**EXHIBIT NO. 1**  
**APPLICATION NO.**  
**A-6-PSD-09-43**  
 Land Use Map

EXHIBIT NO. 2
APPLICATION NO.
<b>A-6-PSD-09-43</b>
Figure 5.3 of NEVP
Incorp'd by Ref. Into PMP
California Coastal Commission

**Project:** North Embarcadero Visionary Plan, Phase 1 Coastal Access Features Project

**Figure 5.3**  
Section of Bayfront Esplanade

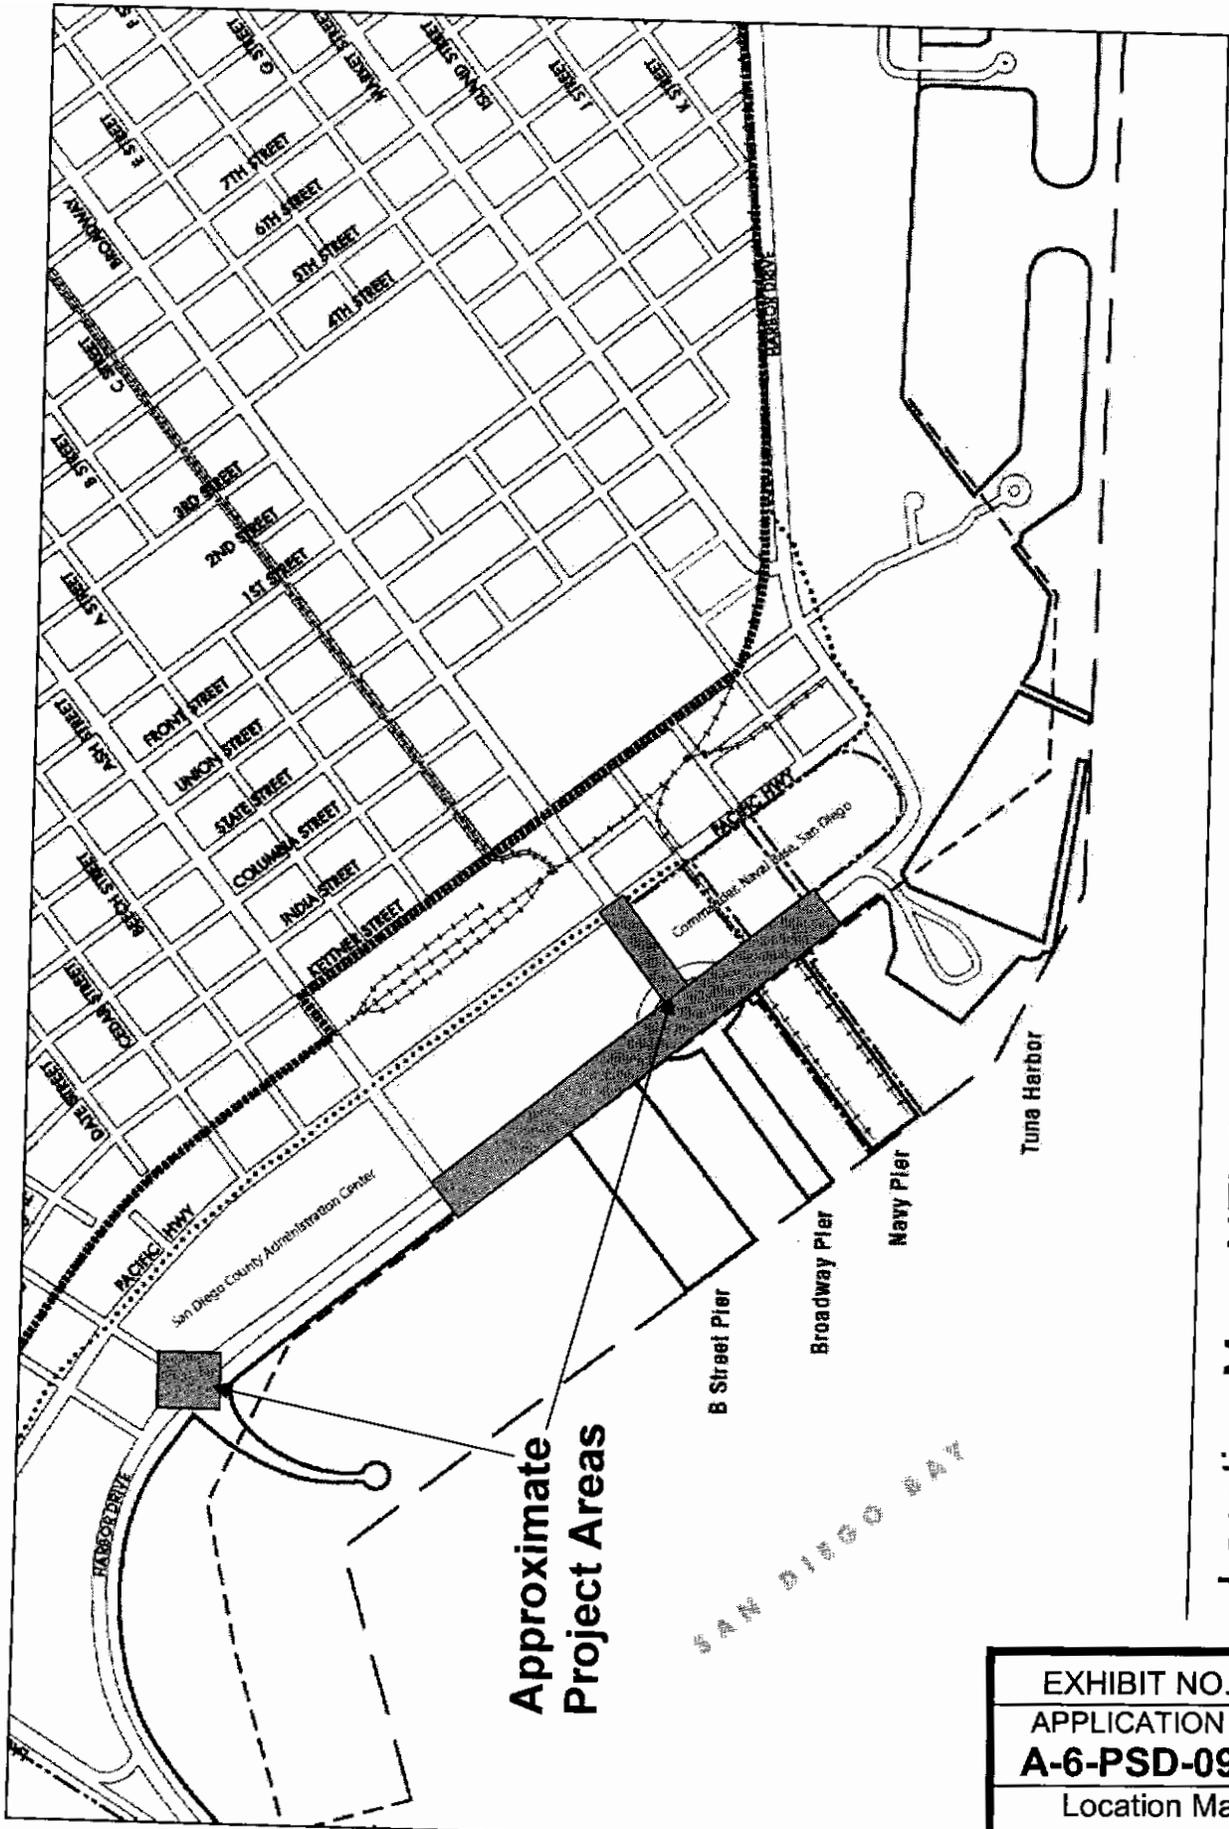
The certified PMP also incorporates by reference Figure 5.3 of the NEVP. Once a policy, figure, or project is inserted into the PMP, it is no longer guidance, but the standard of review. The configuration of the proposed esplanade is significantly different than the one in Figure 5.3. Perhaps most significantly, a 10-foot wide designated bike path has been combined with the pedestrian walkway to make a 29-foot wide multi-use promenade. Port staff have indicated that local bicycle organizations have expressed a preference for Pacific Highway as the primary, designated north-south bikeway in the Embarcadero. Commission staff agree with the intent of the revised plan to still accommodate bicycles on the Esplanade, but in other areas, we have seen significant conflicts between bicycles and pedestrians on shared-use paths. Again, the shifting of the primary bicycle route to Pacific Highway and the joint accommodation of bicyclists and pedestrians on one path, should be reflected in a broader PMP-level analysis of interests and priorities for public access along the shoreline that goes beyond the scope of this one permit.

The certified PMP also incorporates by reference Figure 5.3 of the NEVP. Once a policy, figure, or project is inserted into the PMP, it is no longer guidance, but the standard of review. The configuration of the proposed esplanade is significantly different than the one in Figure 5.3. Perhaps most significantly, a 10-foot wide designated bike path has been combined with the pedestrian walkway to make a 29-foot wide multi-use promenade. Port staff have indicated that local bicycle organizations have expressed a preference for Pacific Highway as the primary, designated north-south bikeway in the Embarcadero. Commission staff agree with the intent of the revised plan to still accommodate bicycles on the Esplanade, but in other areas, we have seen significant conflicts between bicycles and pedestrians on shared-use paths. Again, the shifting of the primary bicycle route to Pacific Highway and the joint accommodation of bicyclists and pedestrians on one path, should be reflected in a broader PMP-level analysis of interests and priorities for public access along the shoreline that goes beyond the scope of this one permit.

The referenced Figure 5.3 of the NEVP is an illustrative plan that shows a representative cross section from an undefined point along the envisioned approximately 1.5 mile long esplanade and roadway along North Harbor Drive. The cross section is typical, not prescriptive, and it could not be prescriptive because the actual width of the esplanade and right-of-way varies at different sections of the esplanade and right-of-way, such as where structures would exist, where access to piers is necessary, etc. The text of the PMP deliberately establishes the minimum for the breadth of the esplanade (no less than 100 feet) in recognition of the substantial length of esplanade and the diversity of hardscape and softscape elements conceived. The cross section merely establishes representative project elements, a suggested order to those elements, and the general aesthetic intent of the esplanade and roadway as envisioned. As described, the Project includes all of the elements shown within the cross section, in order, and refines, while remaining consistent with, the general aesthetic intent.

The Figure 5.3 referenced is itself described in the NEVP as a 'typical' cross section from an undefined point along the envisioned approximately 1.5 mile long esplanade and roadway along North Harbor Drive. The cross section is typical, not prescriptive, and it could not be prescriptive because the actual width of the esplanade and right-of-way varies at different sections of the esplanade and right-of-way, such as where structures would exist, where access to piers is necessary, etc. The NEVP is not a prescriptive plan; rather a concept plan as stated on page 1 of the NEVP: "The purpose of the Plan is to establish a concept for public improvements, and strategies to finance them, befitting the setting and regional significance of the area, and to guide private development in a way that optimizes property values and reinforces the public realm." Port staff agrees with Coastal staff comment b, that consistency with the NEVP is not at issue. Subsequently Port staff does not agree with this comment.

**EXHIBIT NO. 8**  
**APPLICATION NO.**  
**A-6-PSD-09-43**  
**Oval Park Size**  
**Assessment**  
 California Coastal Commission

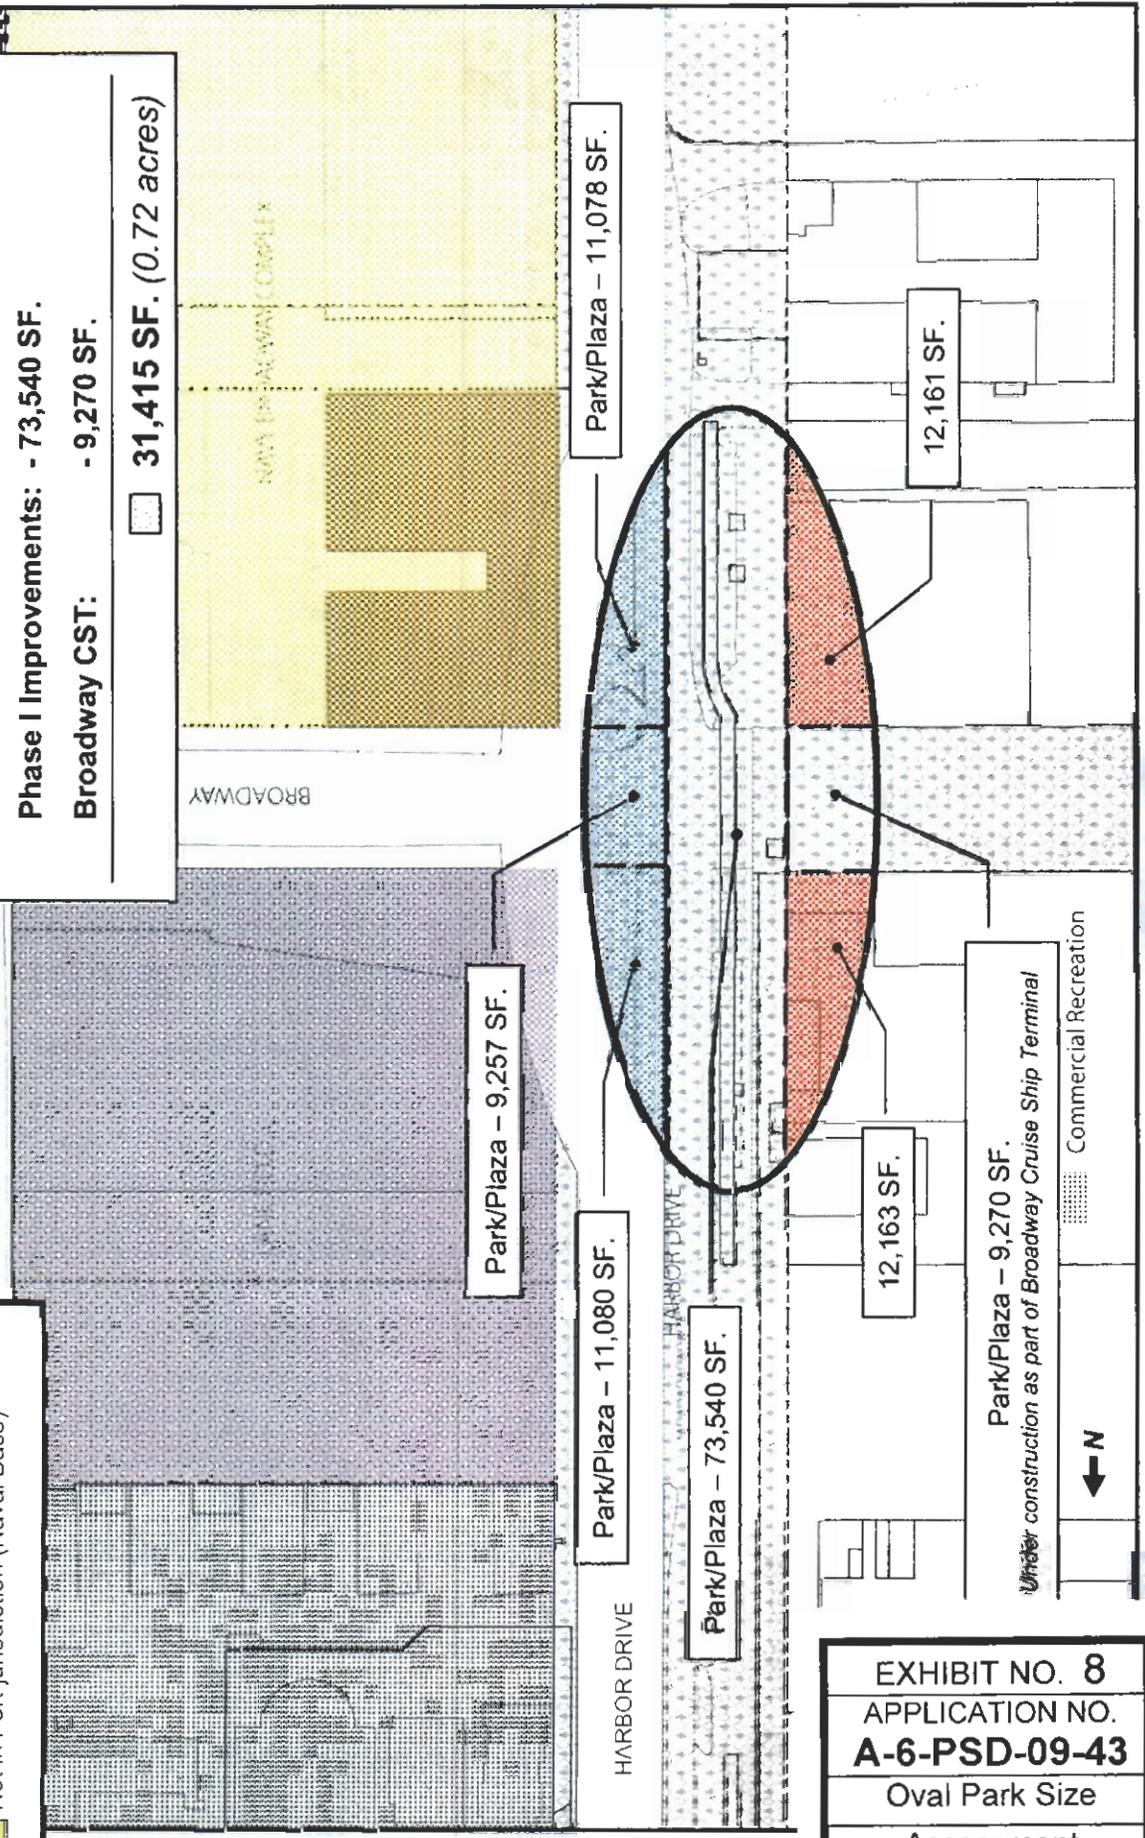
Figure 11 of the PMP graphically demonstrates Harbor Drive curving at West Broadway Street to accommodate an oval-shaped park at the foot of Broadway Pier. Port staff have estimated that this park would be approximately 79,200 sq.ft. in size, (including some amount of area that would be necessary to allow access to the pier from Harbor Drive), with another 24,300 sq.ft. potentially needing to be located in a new over-water structure. In its place, an approximately 16,000 sq.ft. rectangular plaza/pier entrance is proposed, along with 63,000 sq.ft. of esplanade on either side of the plaza, and approximately

Figure 11 of the PMP graphically demonstrates Harbor Drive curving at West Broadway Street to accommodate an oval-shaped park at the foot of Broadway Pier. Port staff have estimated that this park would be approximately 79,200 sq.ft. in size, (including some amount of area that would be necessary to allow access to the pier from Harbor Drive), with another 24,300 sq.ft. potentially needing to be located in a new over-water structure. In its place, an approximately 16,000 sq.ft. rectangular plaza/pier entrance is proposed, along with 63,000 sq.ft. of esplanade on either side of the plaza, and approximately 124,500 sq.ft. of sidewalk setbacks and plaza on the north and south side of Broadway, including the proposed park on the northwest corner of the Navy Broadway Complex/Manchester Pacific Gateway.

The oval depicted on Figure 11 is not a specific project design, but rather a conceptual, illustrative, designation of land uses within the Phase 1 Project area. Translating the oval land use designation into an oval park plaza design would have required the District to acquire Navy property (southeast corner of Broadway/North Harbor Drive intersection) and remove existing Navy buildings, renegotiate the Lane Field lease, amend the California Coastal Commission Coastal Development Permit issued for Lane Field (northeast side of Broadway/North Harbor Drive intersection), and cause hitherto unevaluated impacts of constructing new wharf area over currently un-shaded waters of the Bay. Because the geometry cannot be achieved in half all of these precursors would be necessary to implement an oval.

The District redesigned the rectangular plaza at the foot of Broadway in a manner that maintains the same level of park plaza land use area available to the public as that discussed in the PMP. This is achieved with setbacks along West Broadway that the developers on the north and south sides will implement. The reconfiguration results in the scenic North Harbor Drive having an alignment within the oval depicted on Figure 11
